**DESIGN REVIEW BOARD
AGENDA
Wednesday, September 14, 2016, 6:30 p.m.
Council Chambers, 209 S. Main Street, 2nd Floor**

RE: Planning Staff Report – Sleep Inn

RE: Planning Staff Report – Primrose School

RE: Planning Staff Report – Moo Moo Express Car Wash

LANDSCAPE PLAN
C4

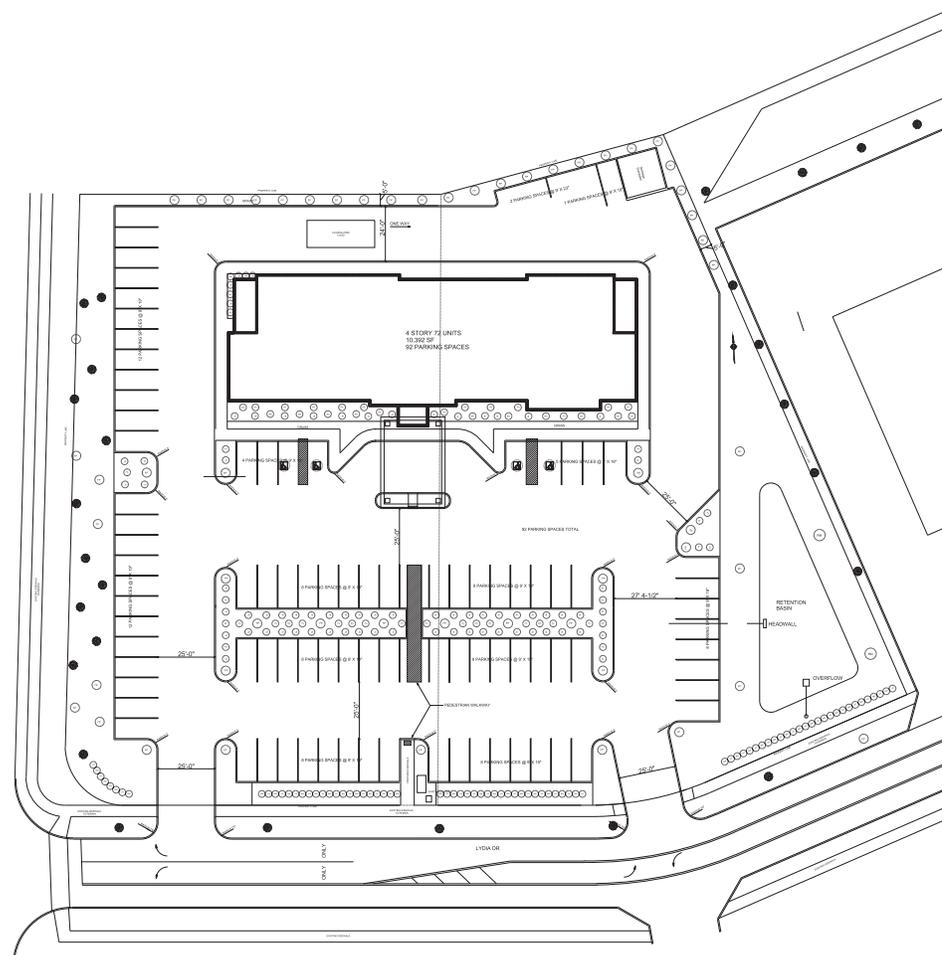
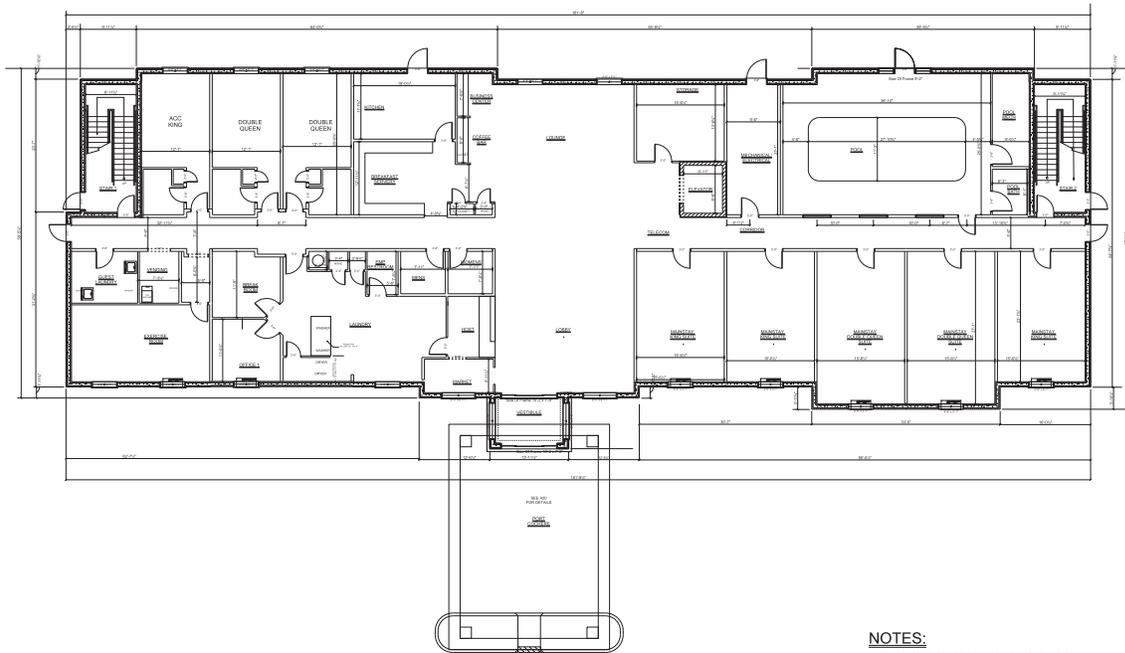
Staff has major concerns with the proposed landscaping plan. The board may wish to discuss the layout, proposed plant material list and the thought behind the location of those plants. The proposed plan has no consistency and appears to locate plants randomly in planting beds in order to fill the area. Staff also has concerns regarding the size and spacing of the proposed plants. The proposed plans are not well thought out and do not consider plant sizes when at full maturity. Some plant material is spaced to close together, while other areas show plant material spaced to far apart. Trees and shrubs are not shown in any hierarchy for plant size on the plans.

The Landscape plan provides a limited variety of shade tree plantings on-site. Staff recommends providing a variety of trees to protect from loss of large quantities of trees due to insect/disease. Staff also suggests replacing the *Pyrus calleryana* (Flowering Pear) with a large shade tree found on the approved City of Marysville Street Tree Planting List.

Foundation planting are scattered and have no consistency or structure. Staff suggests grouping shrubs to create hedges and massing's. Staff also suggests adding small shrubs in front of the hedges to layer the plants and add interest and depth. Staff suggests adding plant material that provides color (flowers) to add interest to the site. Staff also suggests adding foundation plantings on the north, west and east elevations.

Staff suggests not using the Pampas Grass (*Cortaderia selloana*) and Medium Juniper in the landscape plan. These plants are not pedestrian scale and are more appropriate for service and utility screening purposes.

1. The applicant shall combine the parcels to create a single parcel through the applicable City and County entities.
2. Applicant show the correct setback lines on-site.
3. Applicant provide a revised landscape plan.
4. Use all evergreen shrubs for parking lot screen hedge rows.
5. Update the plant list and provide a variety of shade trees and shrubs.
6. Remove Pyrus calleryanna from the plant list.
7. Remove pampas grass from the plant list.
8. Remove medium Juniper from the plant list.
9. Use dark hardwood mulch in all planting beds.
10. Provide foundation plantings on the north, west and east building elevations.
11. Provide building elevations for all sides of the proposed structure that include building materials and colors.
12. Show and screen all building mechanicals on-site.
13. Provide light pole height, color and material information.

ELEVATIONS
A6

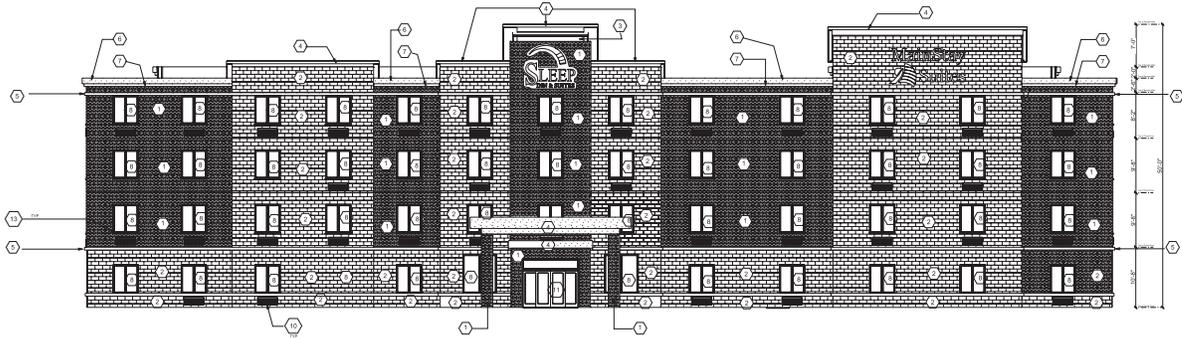
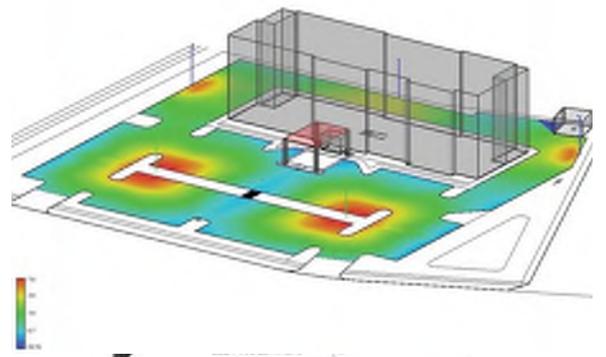
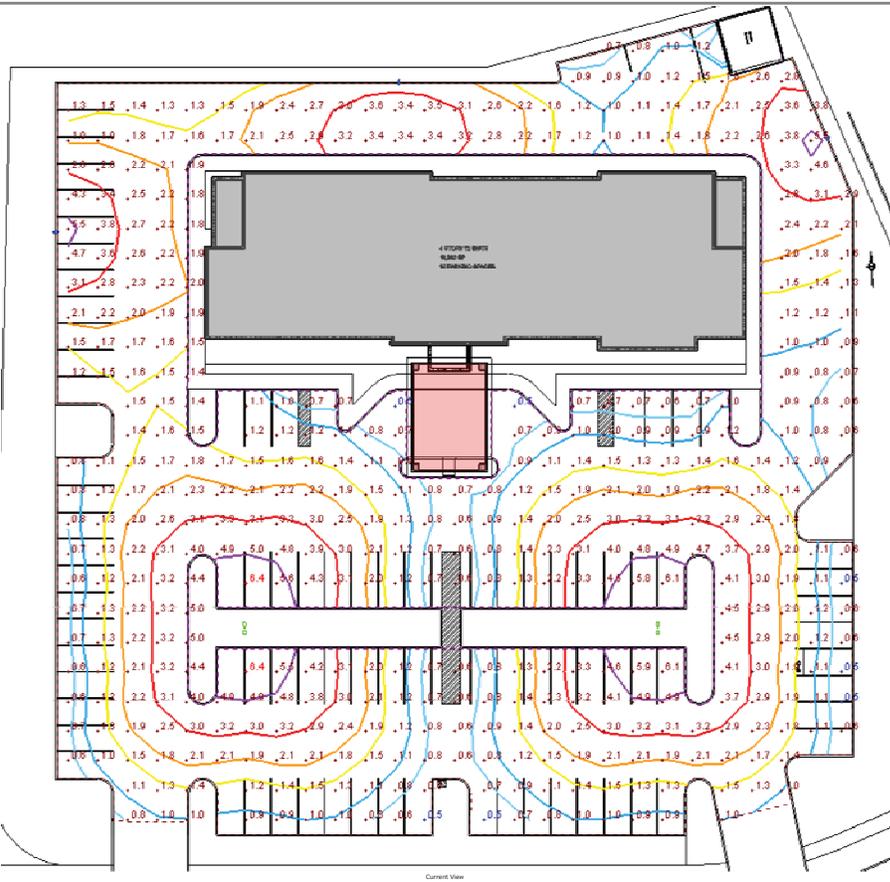
Leon Troyer representing the Management Company and building for the hotel. They are located in Amish Country. The building elevation has been updated to show brick. They want to have a business that looks new even after ten years. Mr. Draughn went through the City Staff comments. Mr. Troyer stated he is working with City Staff to make sure everything is up to code and their expectations of the facility.

SITE PLAN
PRIMROSE SCHOOL OF MARYSVILLE
1600 COBBLESTONE WAY
MARIETTA, OHIO 44130
UNION COUNTY, OHIO 43040

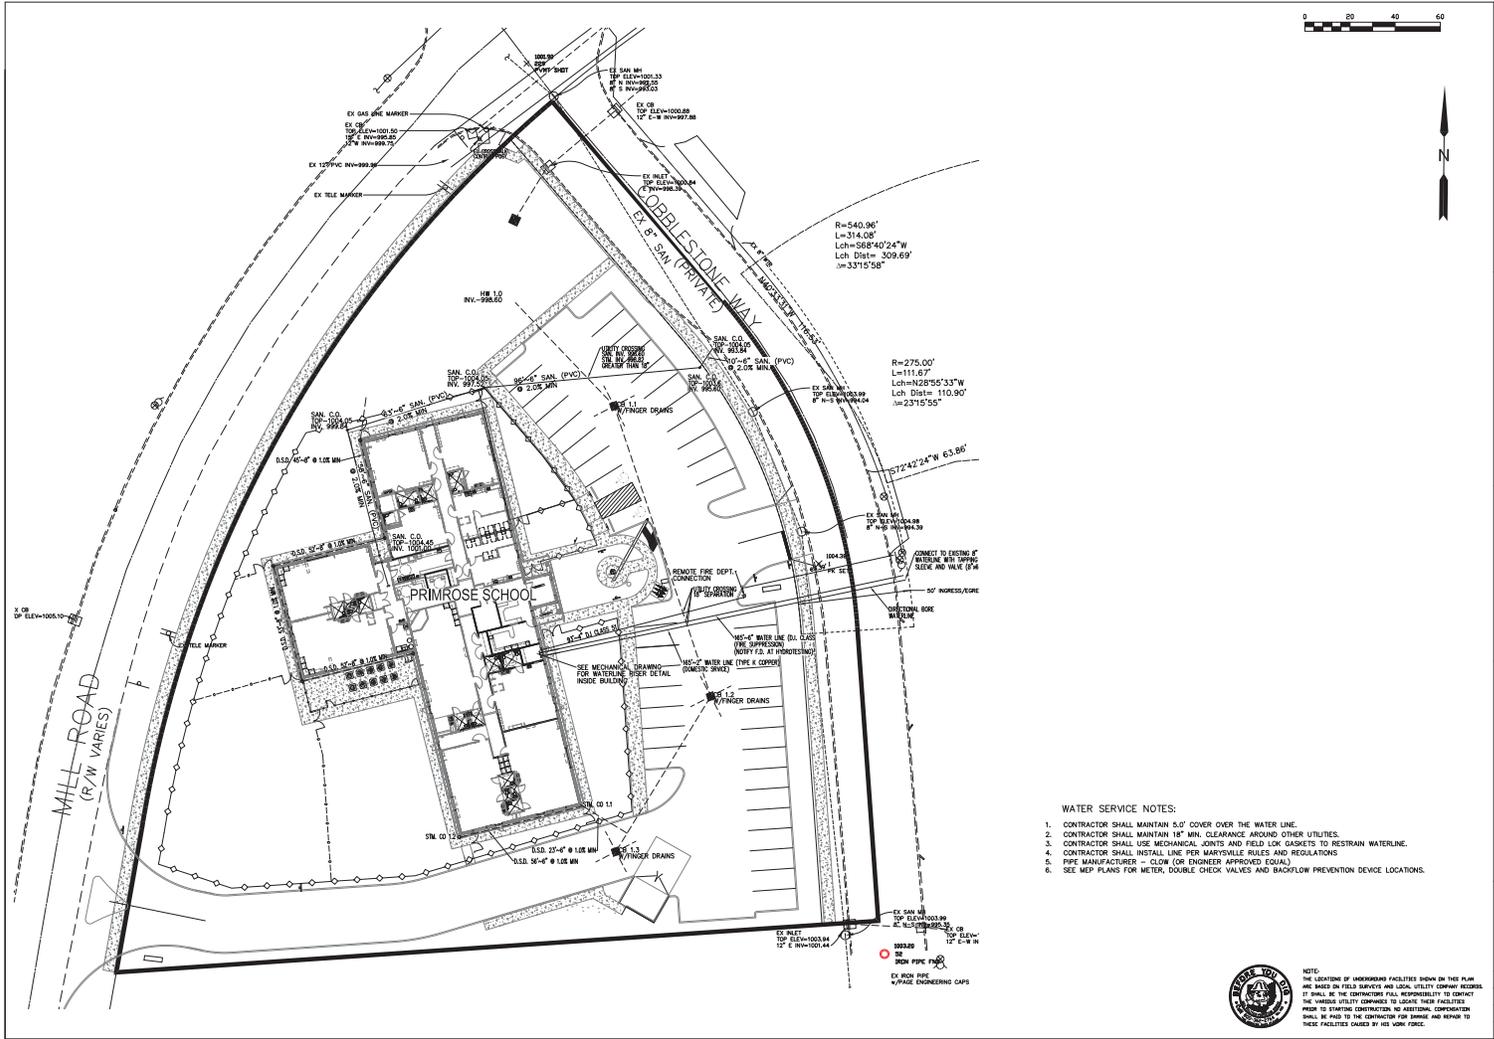
Per section 1144.10 (b)(4) walkways between the public sidewalks and the building entrances shall be provided. The current plans show a sidewalk connection between the Cobblestone Way sidewalk and the front entrance. This sidewalk also connects onto the proposed Mill Road sidewalk.

The applicant has proposed to install fencing in the front and rear of the proposed structure. The plans do not provide a detail for the proposed fence. The applicant will need to provide all fencing details for review and approval. Staff would suggest that all fencing be decorative and black in color. Per City Code fencing is not to be located in the front yard setback. The applicant

The proposed plans label the dumpster enclosure as a ‘masonry trash enclosure’, but no details have been provided. The applicant shall provide detailed elevations of the dumpster enclosure.

1. The applicant receive approval from the Board of Zoning Appeals to allow a fence in the front yard setback.
2. The applicant receive approval from the Board of Zoning Appeals to allow a reduction in total parking required on-site.
3. The applicant shall submit detailed drawings for each outdoor playground equipment that includes all Colors, shape, size and material information.
4. The applicant shall submit detailed drawings for the proposed splash pad for review.
5. The applicant shall provide a tree lawn between the curb and sidewalk along Cobblestone Way.
6. Applicant provide all proposed fencing details.
7. Applicant label and screen any mechanical equipment on-site.
8. Applicant provide light pole details.
9. Applicant provide dumpster enclosure details.

LANDSCAPE PLAN

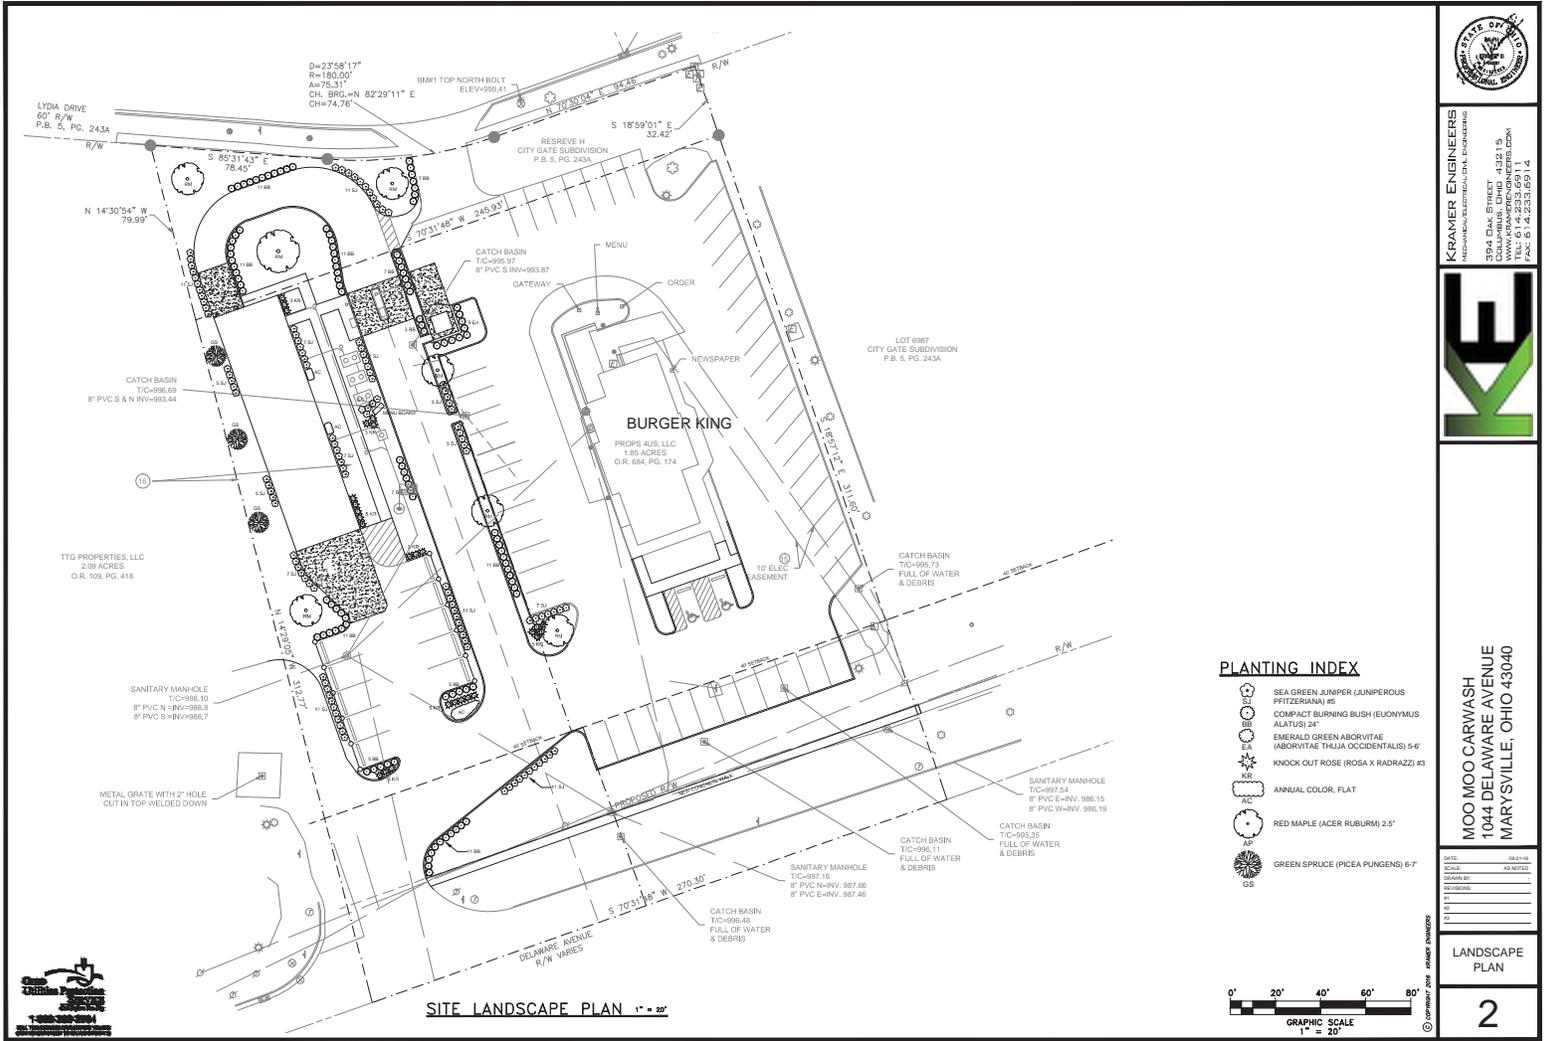
The applicant is proposing to use Sea Green Junipers on-site. Staff suggests removing this plant from the plant list. Staff suggests using Karl Forester reed grass in the islands in place of the Sea Green juniper shrub. Staff suggest using dense yew in place of the Sea Green junipers located along the foundation of the proposed building and along the Delaware Avenue frontage to screen the vehicular use are.

Additional shrubs will need to be added in the proposed hedge row along the Delaware Avenue to screen the vehicular use area and shield vehicle headlights.

Additional parking spaces will be added to the Burger King restaurant as part of this project. Per code section 1140.07(b)(B) a 36" tall hedge row to screen the Burger King parking lot/Vehicular use area along Delaware Avenue and Lydia Drive is required and shall be provided.
